| 8802-3/802.3 REVISION REQUEST |

REQUESTED REVISION:
STANDARD: IEEE Std 802.3ab-1999
CLAUSE NUMBER: 40C.2.1 and Figure 40C-2
CLAUSE TITLE: Auto-Negotiation Transmit state machine add-on
for 1000BASE-T

| REV REQ NUMBER: 1047

Figure 40C-2 as modified by Revision requests 1042 to 1049 - Changes annotated

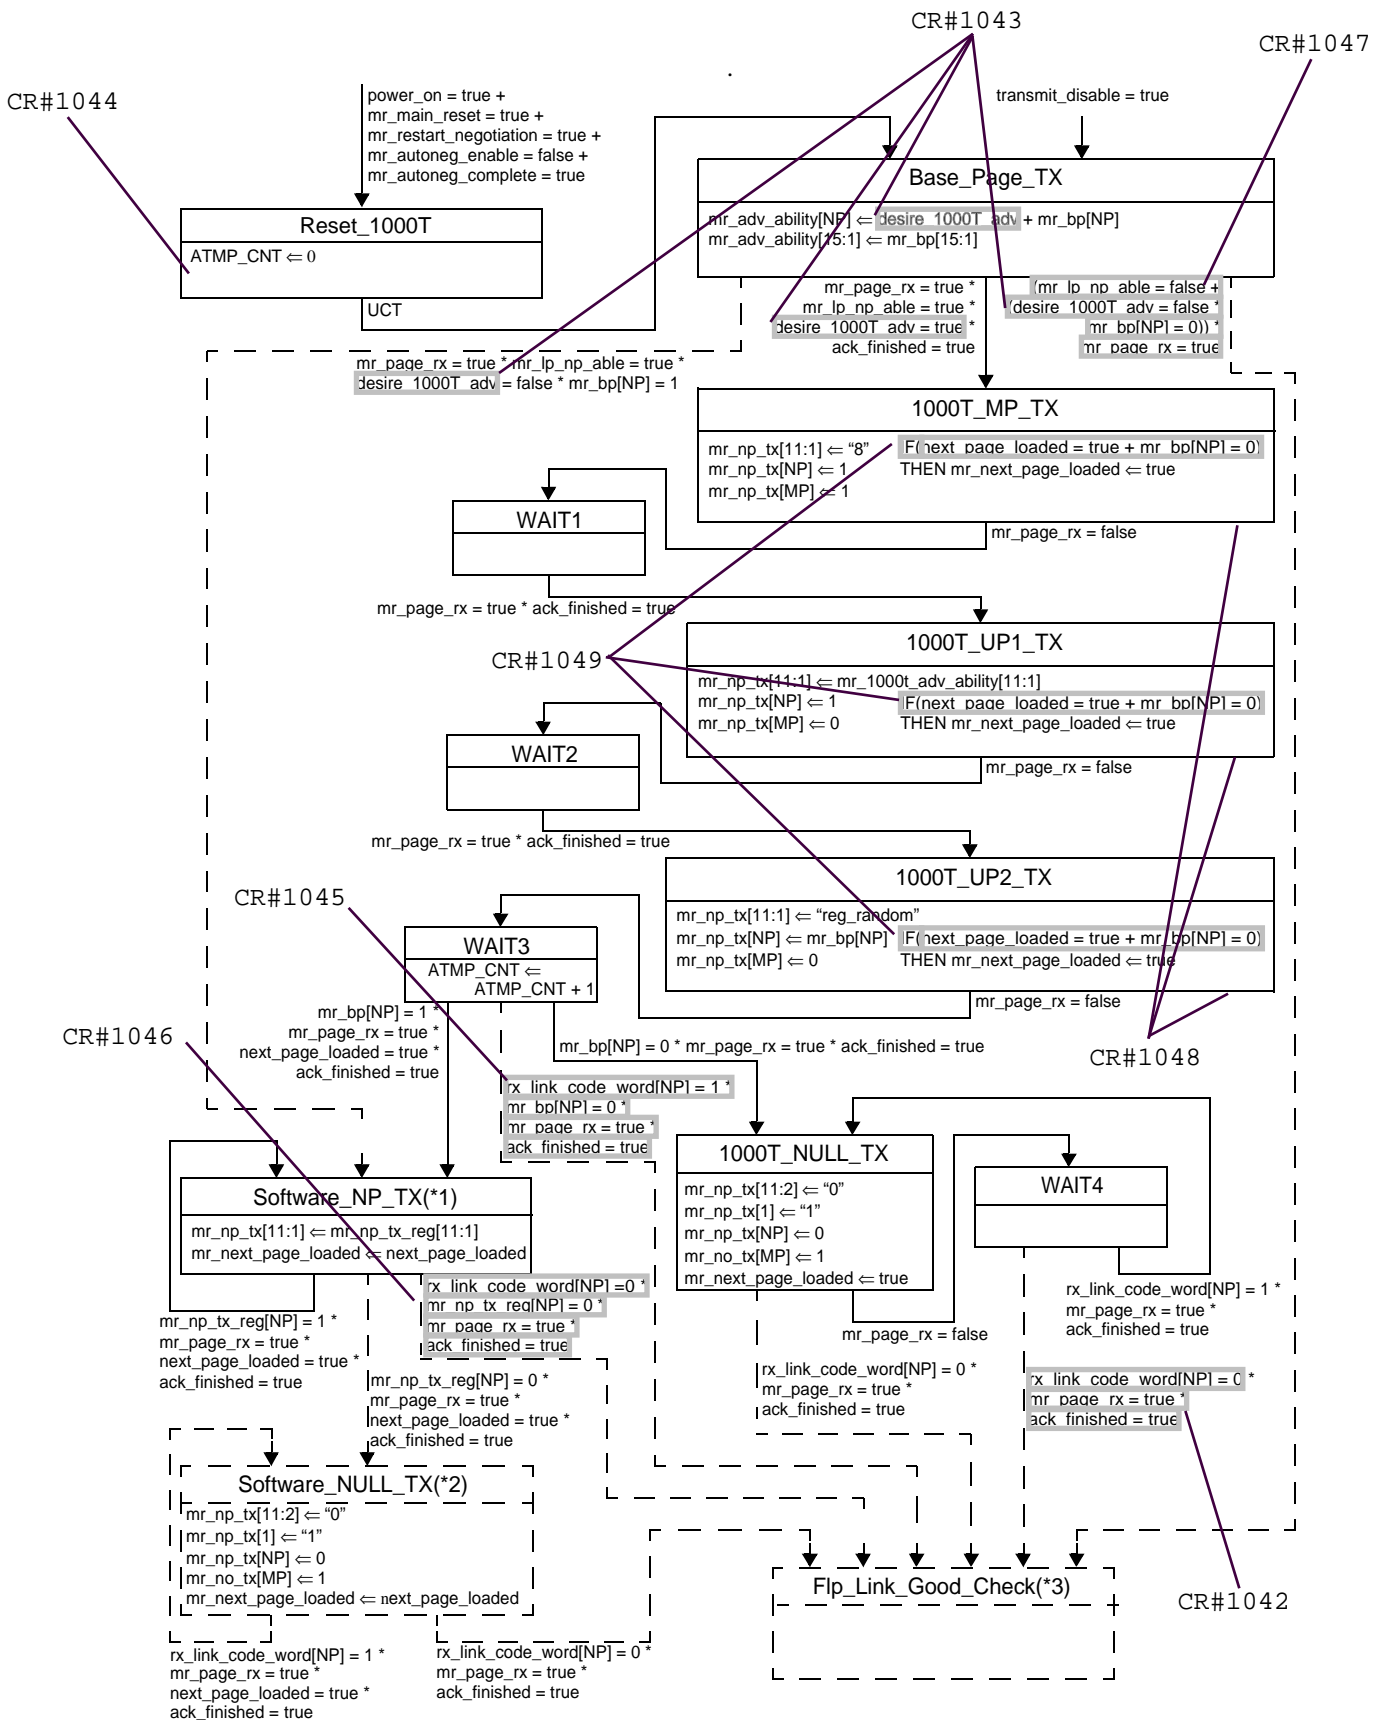
To be consistent with Figure 28-16, I suggest
the transition from the Base_Page_TX state to the
Flp_Link_Good_Check state in Figure 40C-2 should read:

```
(mr_lp_np_able=false + (1000T_capable=false * mr_bp[NP]=0)) *  
mr_page_rx=true
```

The transition from Base_Page_TX to Flp_Link_Good_Check should not be true
until a device goes through the COMPLETE ACKNOWLEDGE state (Figure 28-16,
Arbitration state diagram). In this state mr_page_rx gets set to
true. With the current transition conditions, if a device has
1000T_capable=false * mr_bp[NP]=0, it can transition directly to
Flp_Link_Good_Check.

| ACCEPTED/~~DENIED~~
| COMMENTS: Published IEEE Std 802.3-2002
